**TOWN OF NISKAYUNA**  
***Planning Board and Zoning Commission***  
**Agenda**  
**January 23, 2023 7:00 PM**

AGENDA ITEM NO. VIII. 1

MEETING DATE: 1/23/2023

**ITEM TITLE:** DISCUSSION: 1851 Union St / 1245 Ruffner Road – Mohawk Golf Club – application for sketch plan approval including a Special Use Permit for a 22-lot Average Density Development (ADD) subdivision consisting of 10 single-family detached homes and 12 townhomes.

Drawing Name: **PROPOSED PARKING LOT**

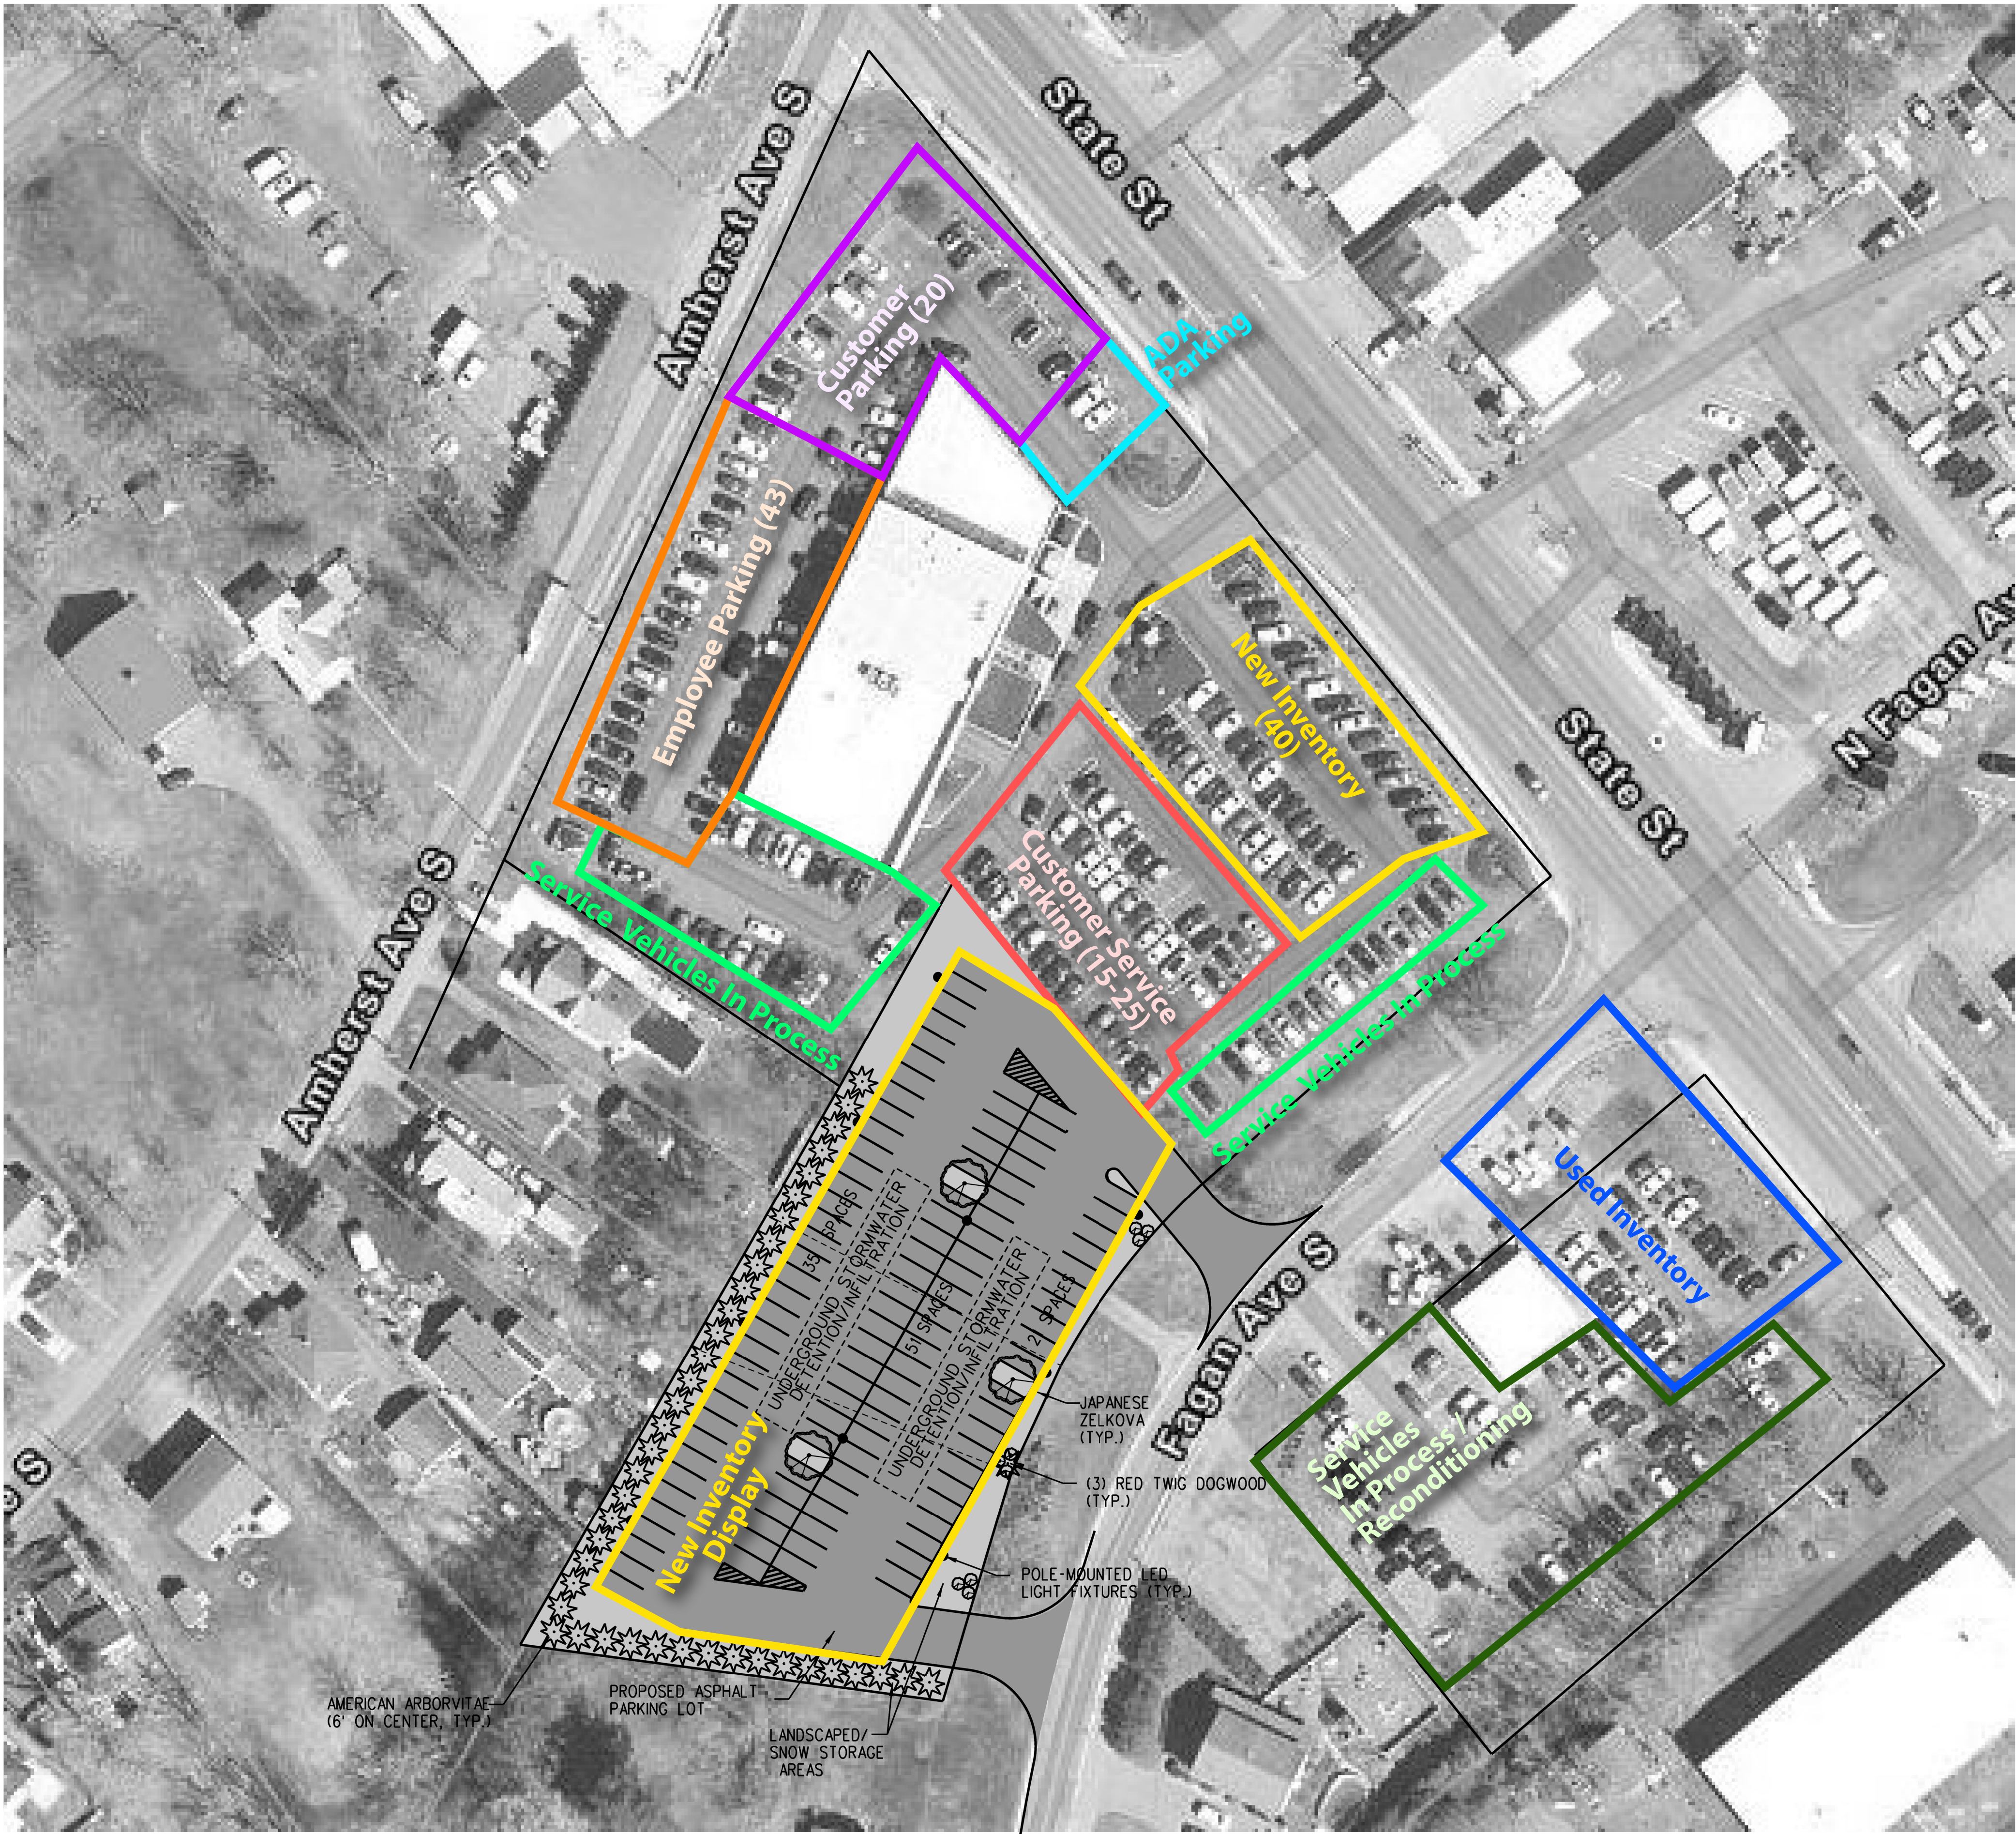
The PB, Planning Office and Mr. Cromer discussed the potential project in significant detail. Mr. Cromer spoke to the concerns of the CAC and proposed mitigation plans and adjustments to the site plan to minimize its impact on the neighboring properties. He noted that the facility across Fagan Ave. is a reconditioning center and is used to detail cars prior to sale. He noted that the use of the area is not optimized and agreed work on improving that situation. The PB noted their primary concern is the potential negative impact the project could have on the neighborhood. The PB requested the following action items be completed for the 1/23/23 PB meeting.

1. Provide an updated site plan that hopes to address the CAC's concerns regarding screening of the proposed parking lot from neighboring properties.
2. Provide a detailed breakout of all parking spaces on the existing lot identifying which spaces are for customers, employees, automobile storage, etc.

Mr. Cromer provided the Planning Office with an updated site plan that includes a vegetative screening of American Arborvitae trees 6' on center along the north and west edges of the proposed combined lot. A version of the updated site plan was marked to identify how each parking space would be used – for customers, employees, storage, etc.

The PB should review and discuss the revised site plans.

**SKETCH PLAN**  
**PHASE 2 - RIVERS LEDGE OF NISKAYUNA**  
**2837 AQUEDUCT ROAD**  
 COUNTY OF SCHENECTADY TOWN OF NISKAYUNA STATE OF NEW YORK  
 DRAWN BY: CHECKED BY: SCALE: 1" = 30'  
 CADD FILE: JOB NO. DATE: MAY 11, 2022  
**SHEET S-1**

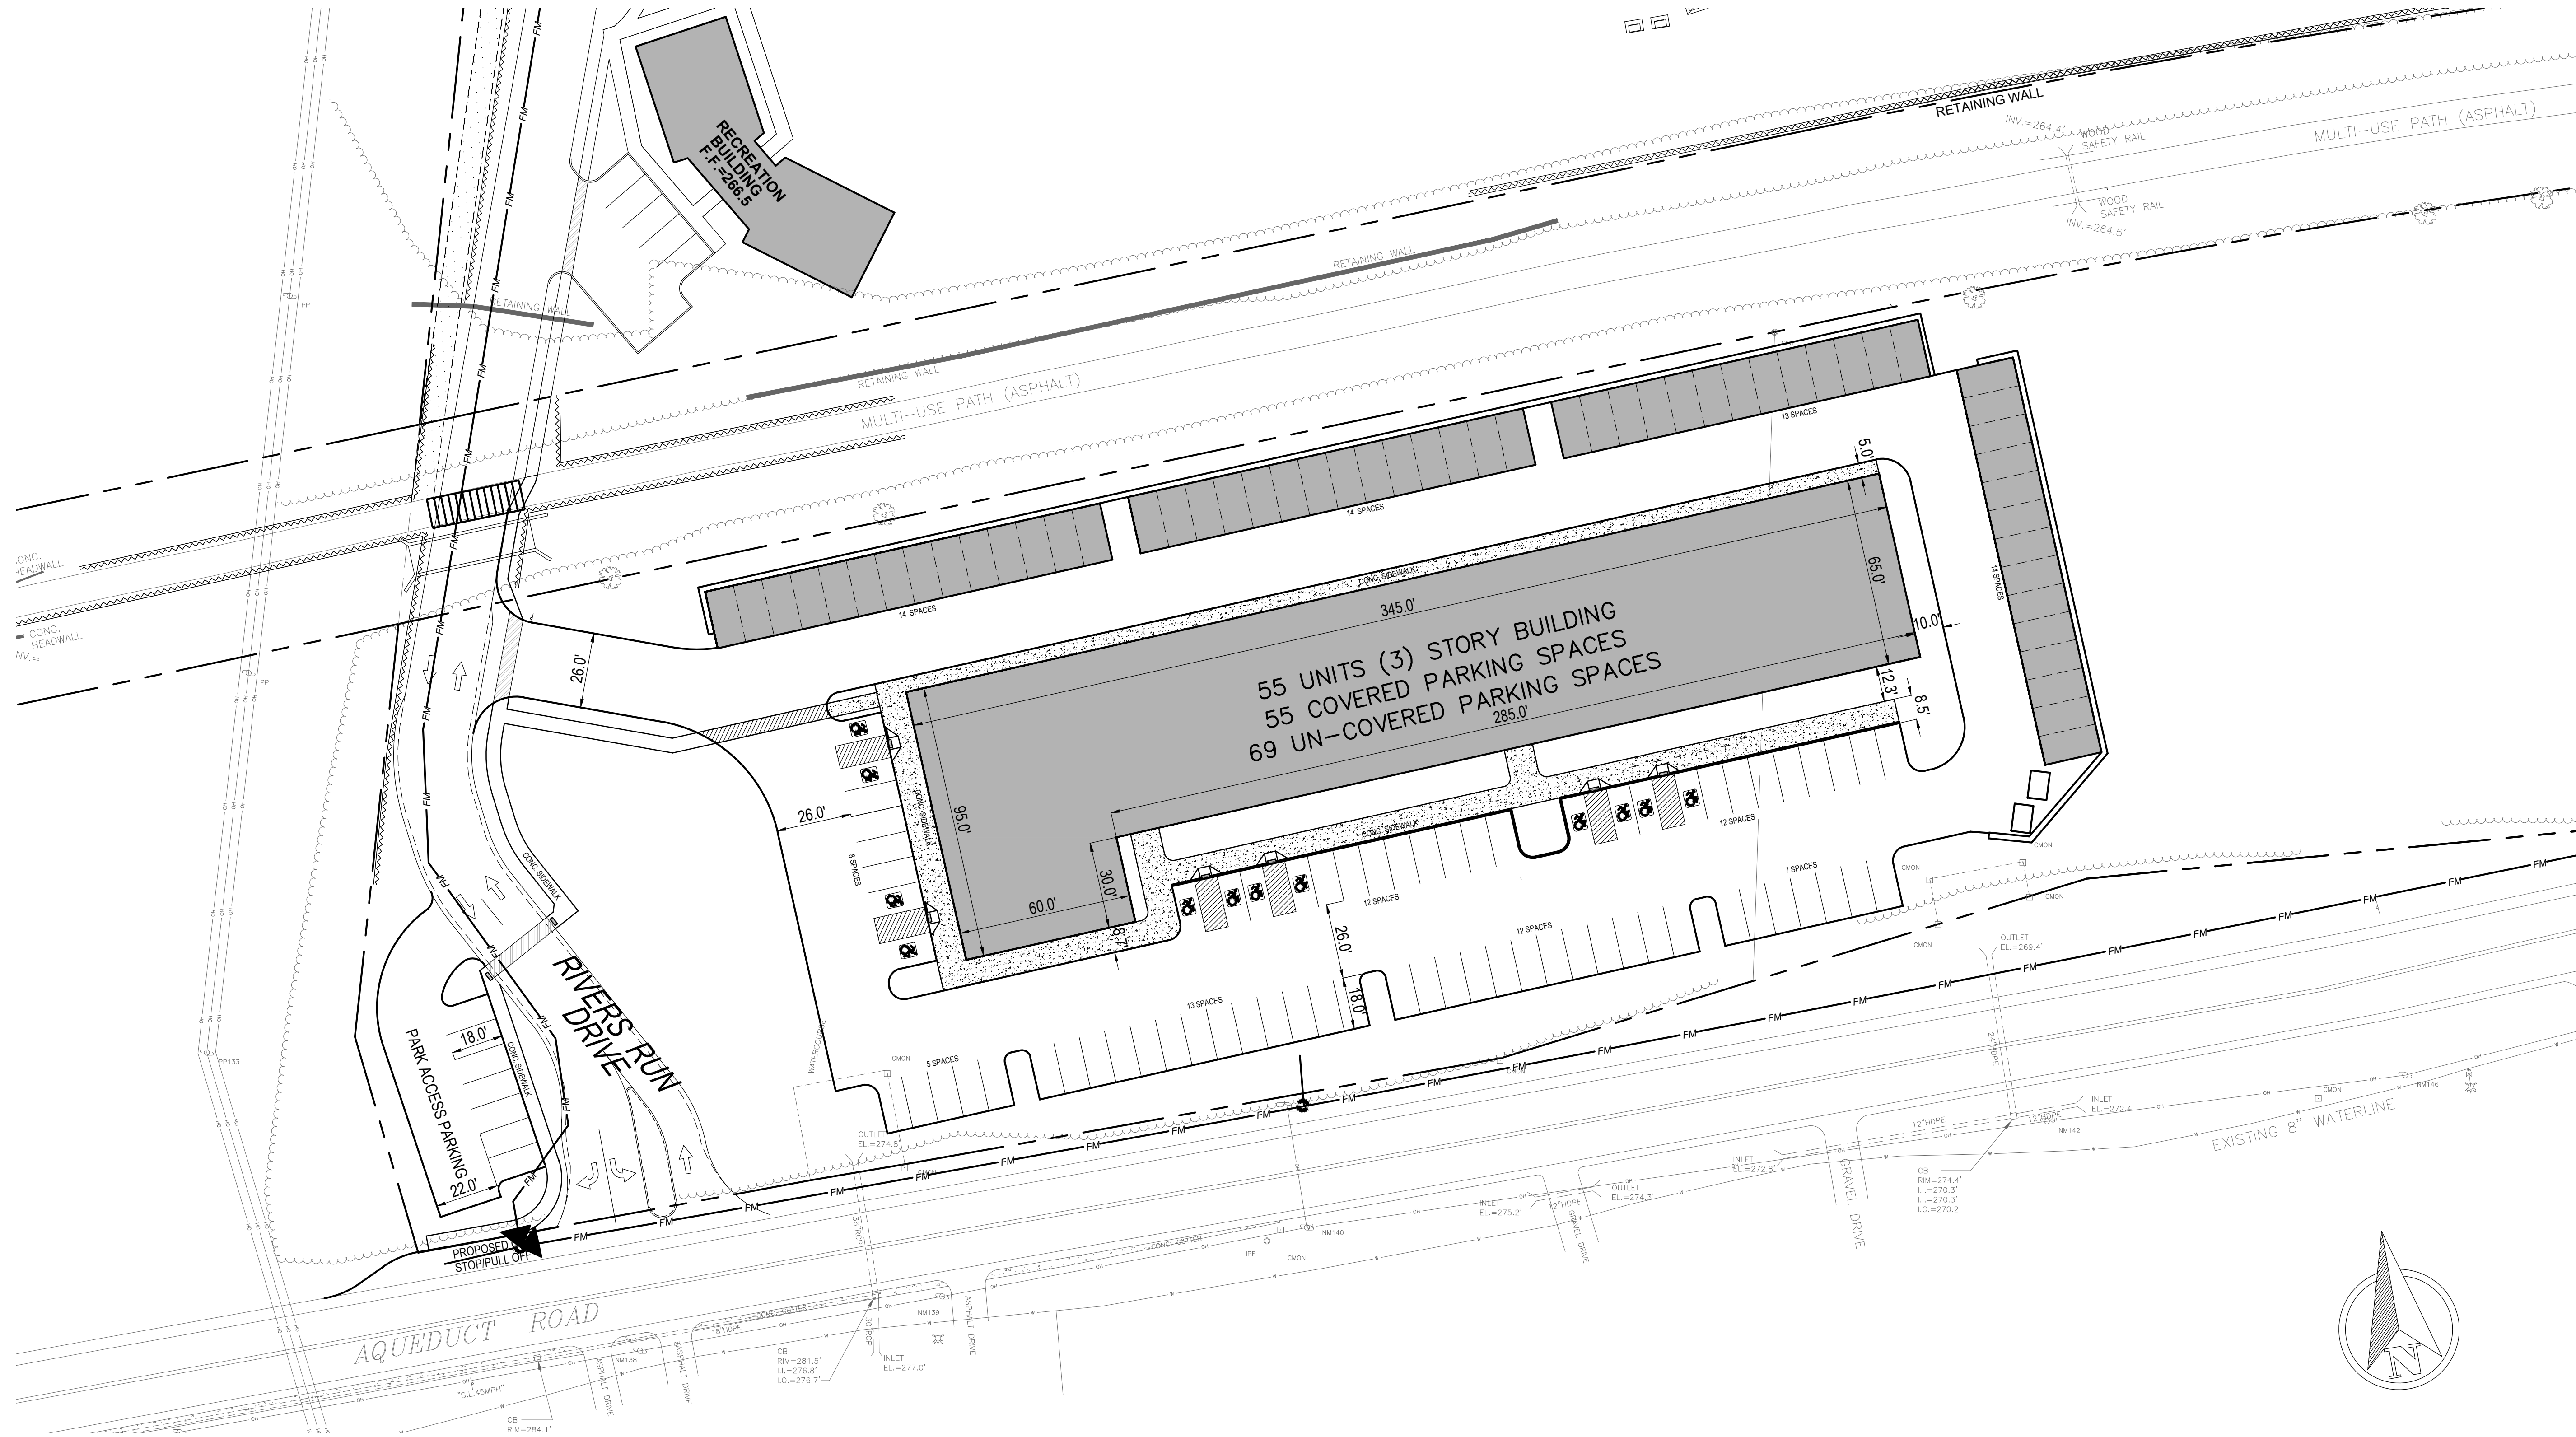
A Rev 3 version of a proposed Rivers Ledge Senior Center was submitted to the Planning Office on 5/19/22. This version includes a building containing 66 senior apartments and 2,000 sq. ft. of mixed use commercial space. The plan includes 66 below grade and 78 grade level parking spaces. A small parking area containing 7 parking spaces is also included to provide access to nearby Aqueduct Park. A second building consisting of 3,000 sq. ft. of commercial space with 11 nearby parking spaces is also included.

- Applicant – work with design team regarding the PB's façade comments
  - Create a rendering showing proposed building with exiting trees around it to help w/scale
  - Explore ways to shorten the height of the building and also make it appear shorter
- PO – schedule a review with the ARB
- PO – provide pictures of Notts Landing to Mr. Pafundi

The Board should review and discuss the revised design.
